CITY OF ALBUQUERQUE

Re: Solare Collegiate Charter School
8801 Gibson Blvd. SW 87121
Traffic Circulation Layout
Engineer's/Architect's Stamp 06-07-2019 (M09D031)

PROJECT SOLARE CHARTER SCHOOL
8801 Gibson Blvd. SW
Albuquerque, NM 87121
TITLE Traffic Control Layout

PHASE CDS

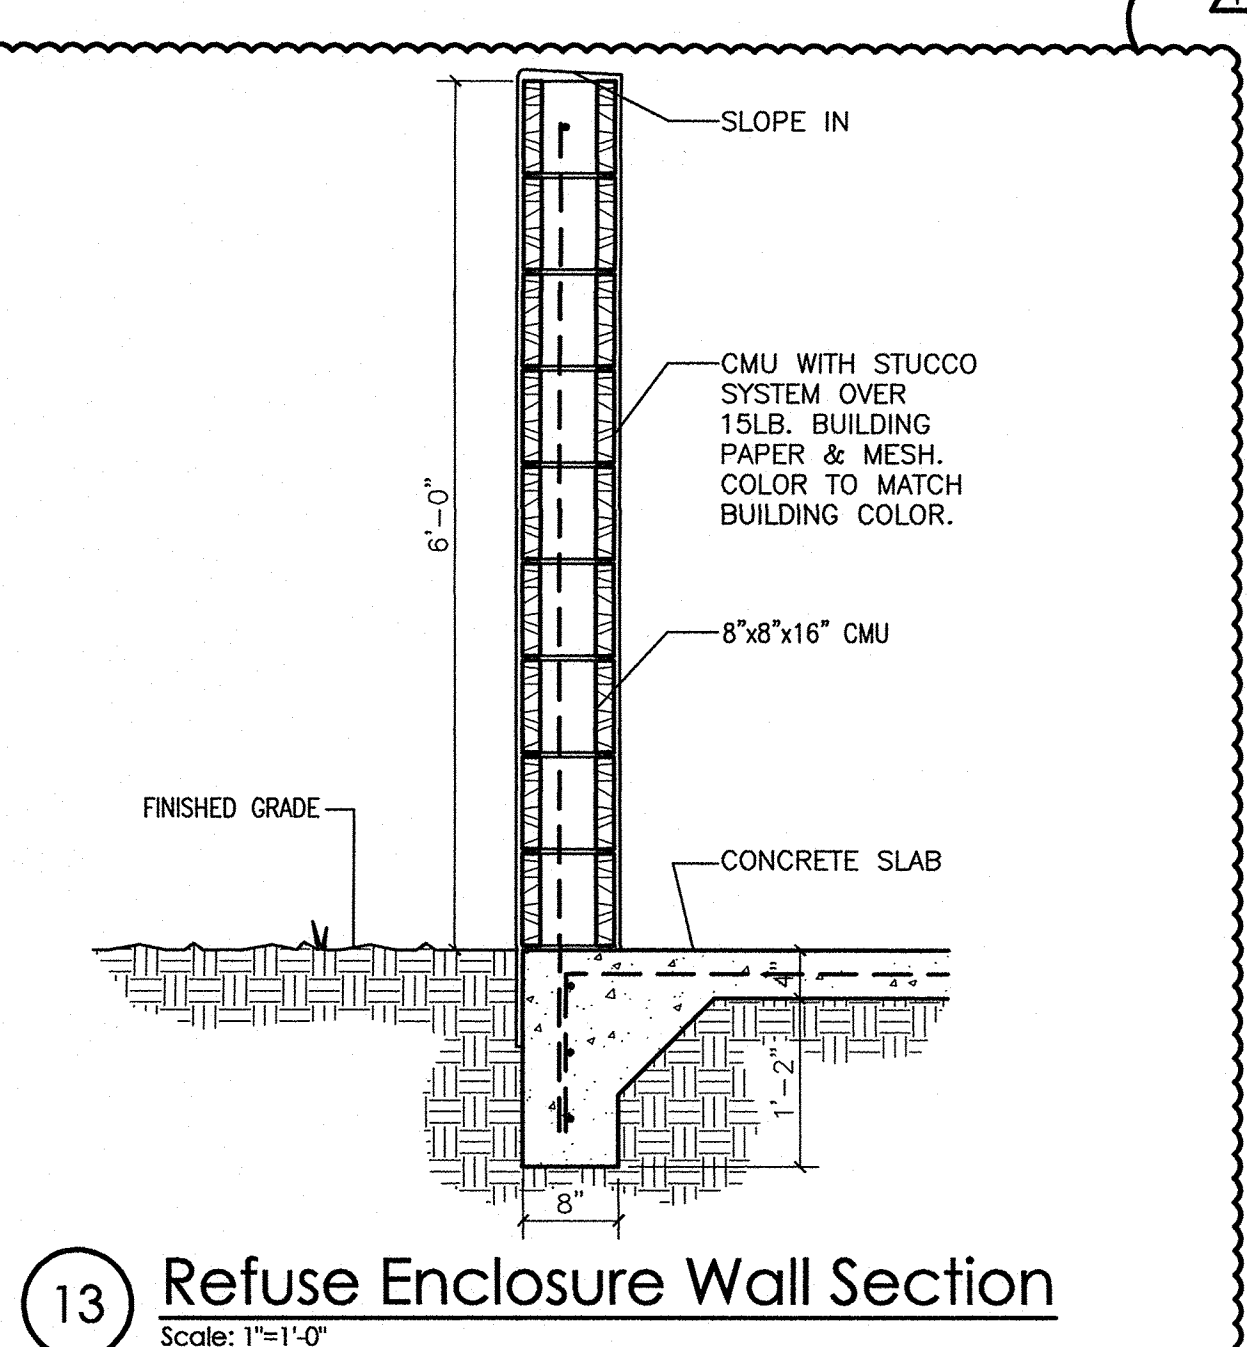
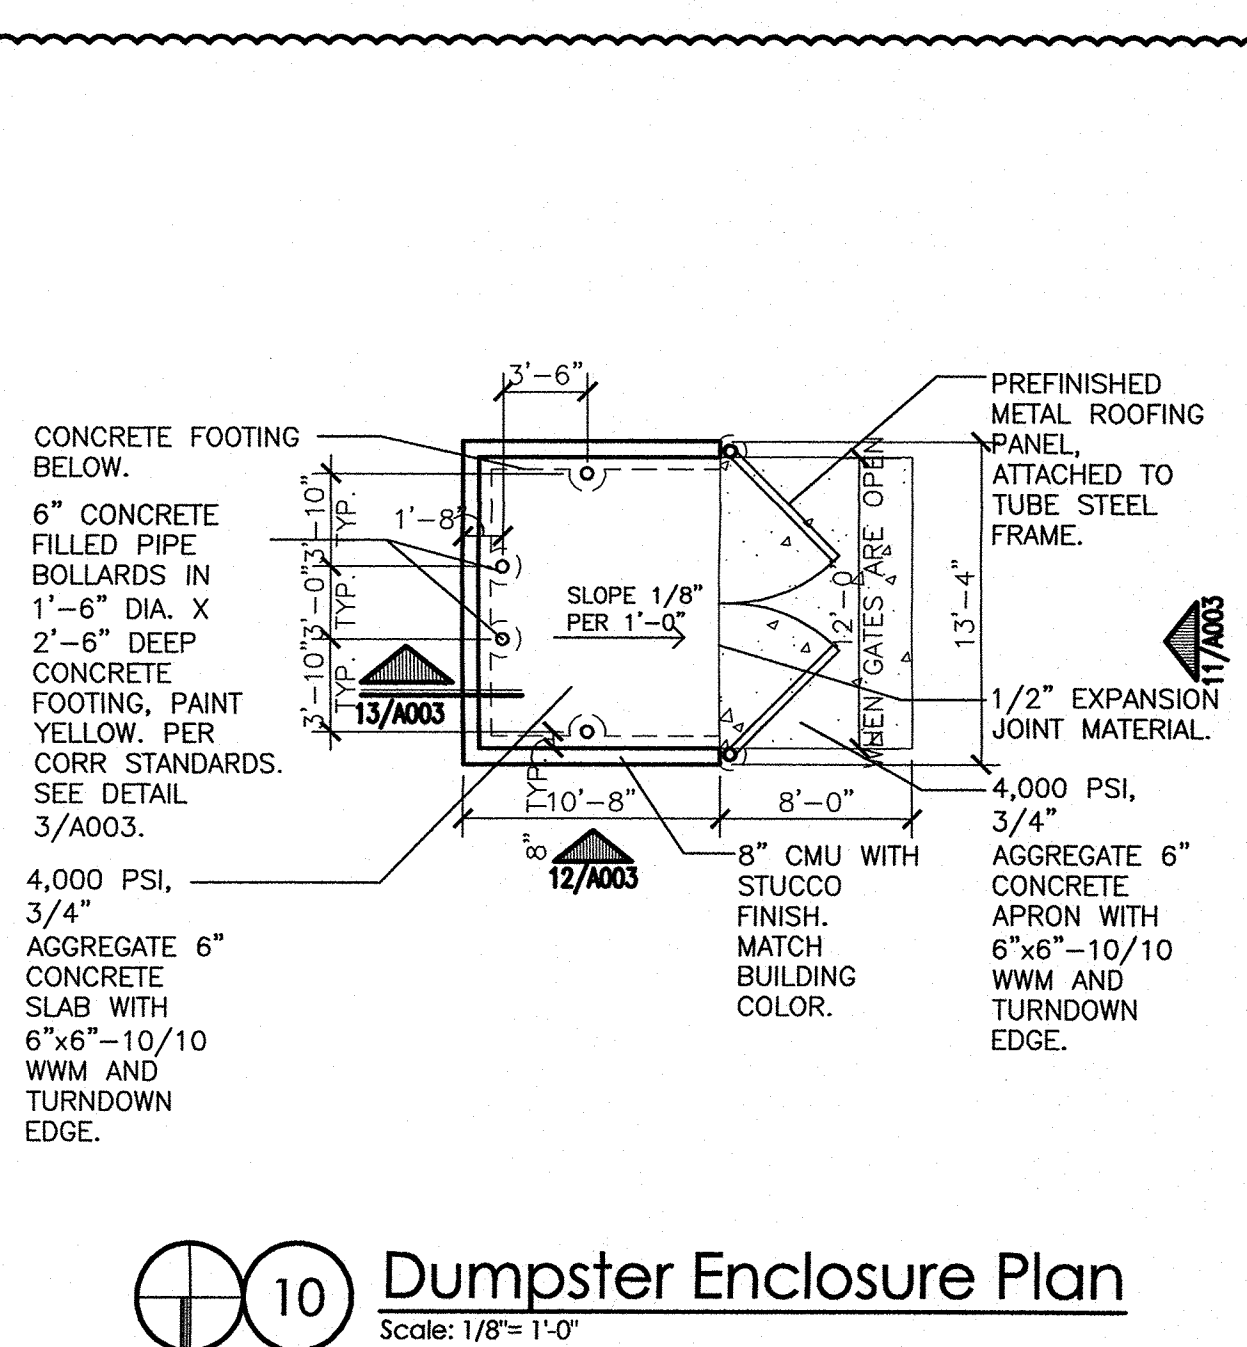
The TCL submittal received 07-23-2019 is approved for Building Permit. Per recommendation from NIA, the transportation requires work order for crosswalk striping and signs. The striping and signs will be checked at the time of the certificate of occupancy. A copy of the stamped and signed plan will be needed for each of the building permit plans. Please keep the original to be used for certification of the site for final C.O. for Transportation.

When the site construction is completed and a Certificate of Occupancy (C.O.) is requested, use the original City stamped approved TCL for certification. Redline any minor changes and adjustments that were made in the field. A NM registered architect or engineer must stamp, sign, and date the certification TCL along with indicating that the development was built in "substantial compliance" with the TCL. Submit this certification TCL with a completed Drainage and Transportation Information Sheet to front counter personnel for log in and evaluation by Transportation.
